RS-03-123

Subject: LaSalle County Station, Units 1 and 2
Facility Operating License Nos. NPF-11 and NPF-18
NRC Docket Nos. 50-373 and 50-374

Response to Request for Additional Information to Support Request for
Amendment to Technical Specifications Table 3.3.5.1-1, "Emergency
Core Cooling System Instrumentation"

**RESPONSE TO REQUEST FOR ADDITIONAL INFORMATION TO
SUPPORT REQUEST FOR AMENDMENT TO
TECHNICAL SPECIFICATIONS TABLE 3.3.5.1-1**

Simplified Sketch
High Pressure Core Spray (HPCS)

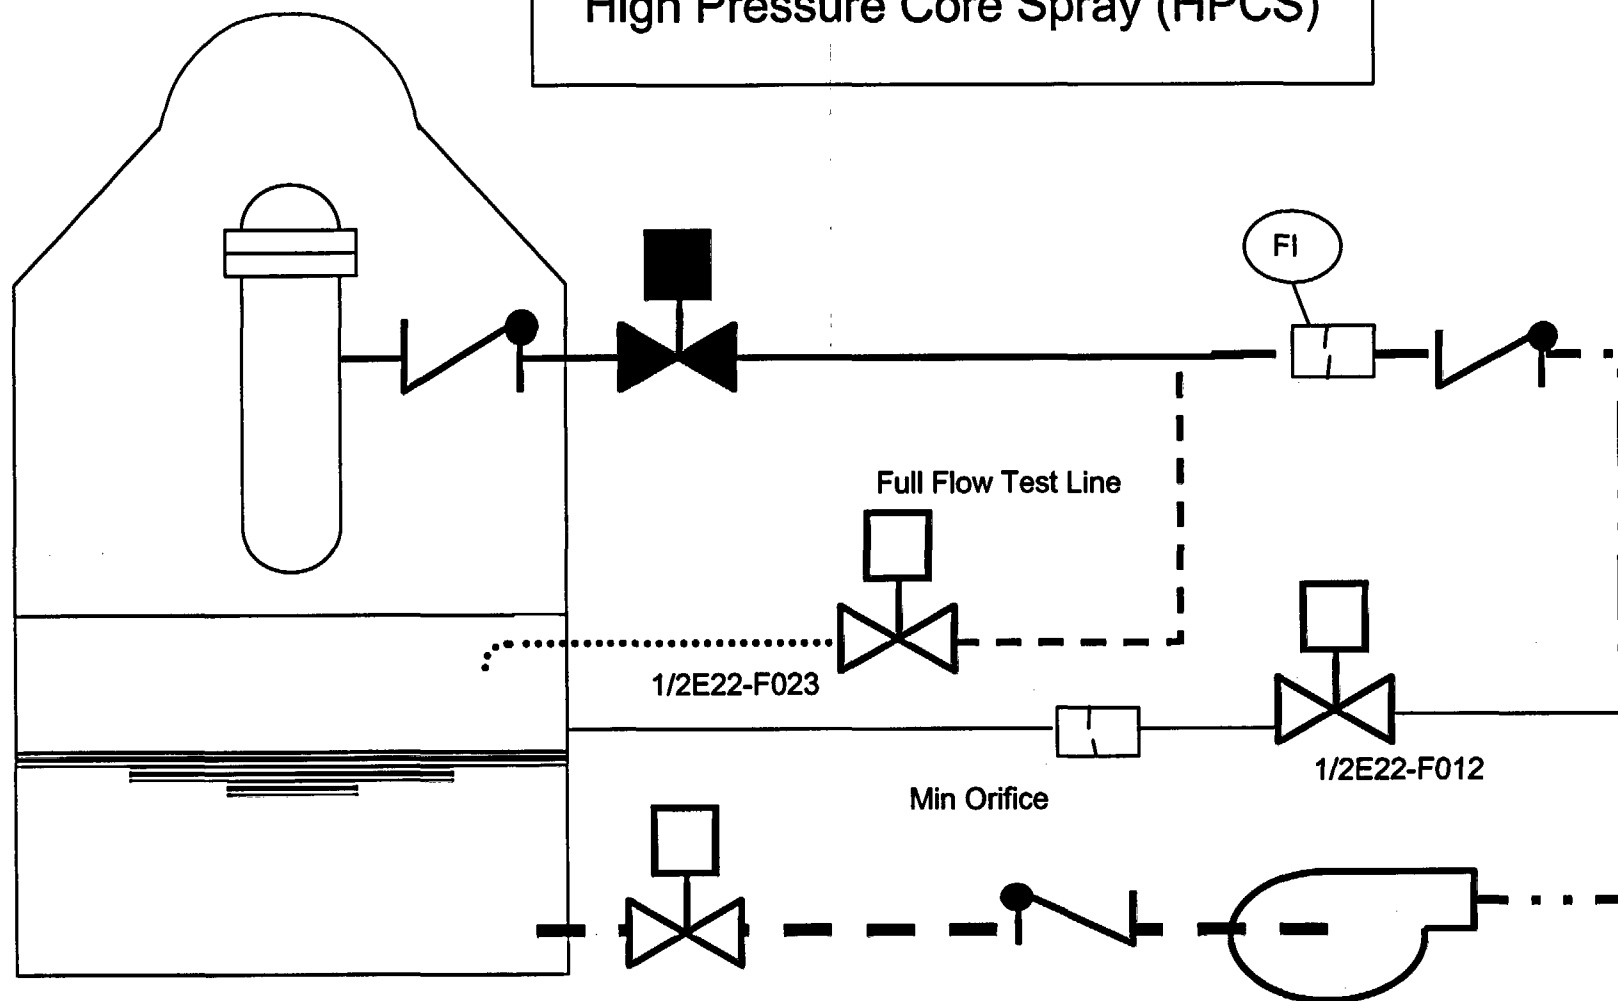
On Page 4 of the submittal there is a reference to loss of coolant (LOCA) analyses. The staff requests the licensee to identify the evaluation models used for the LOCA analyses. In the analyses, the maximum assumed injection flow is 5400 gallons per minute (gpm). In Technical Specifications Surveillance Requirement 3.5.1.5, the tested flow rates are 6250 gpm for Unit 1 and 6200 gpm for Unit 2. The staff requests the licensee to describe in detail how the analyses value of 5400 gpm is verified during the periodic test with the increased minimum flow value of 2194 gpm.

After completion of valve line-ups and verification that the system is filled the following general sequence is followed. Refer to the attached simplified sketch on page 3 of HPCS.

- HPCS pump is started.
- Verify HPCS minimum Flow Valve (1/2E22-F012) OPENS.
- Throttle open HPCS Suppression Pool valve (1/2E22-F023) to establish a flow rate of 6300 gallons per minute (gpm) as indicated on 1/2E22-R603, HPCS Pump Flow Indicator. Note input to the recorder is from a flow orifice in the HPCS pump discharge line downstream of the minimum bypass line but upstream of the full test line.

- Verify HPCS minimum Flow Valve (1/2E22-F012) CLOSES
- Using HPCS Suppression Pool valve (1/2E22-F023) set flow rate to 6300 to 6400 gpm as indicated on 1/2E22-R603, HPCS Pmp Flow and Record flow.

In addition, when the flow into the RPV is 2194 gpm, with the minimum flow valve open, the HPCS pump discharge pressure is approximately 1080 psig; the corresponding pump flow is approximately 3100 gpm with 909 gpm going through the minimum flow line. As shown in Updated Final Safety Analysis (UFSAR) Figure 6.3-10, the required flow into the RPV at 1080 psig is approximately 1300 gpm. Therefore, there is an excess flow into the RPV of approximately 900 gpm (i.e., 2194 gpm-1300 gpm).
